Access Compliance Report Public Rights-of-Way (Curb Ramps)

Main Street: **E_WHITECAP_AVE** Cross Street: **ORANGE_OLIVE_RD** Location: **SE**

ADA ID: **RPAT210924143039** Ramp Type: **Type 1 - Perpendicular** Initial Pass/Fail: **Pass** Overall Compliance: **No** Severity Score: **0**

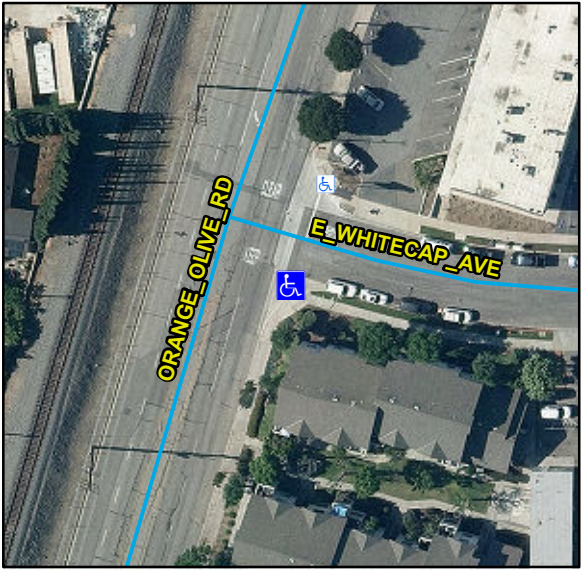
OC Std/PROW:
R304.2.2, R304.2.1, STD 1115

Possible Solutions:
Remove & Replace Entire Ramp.
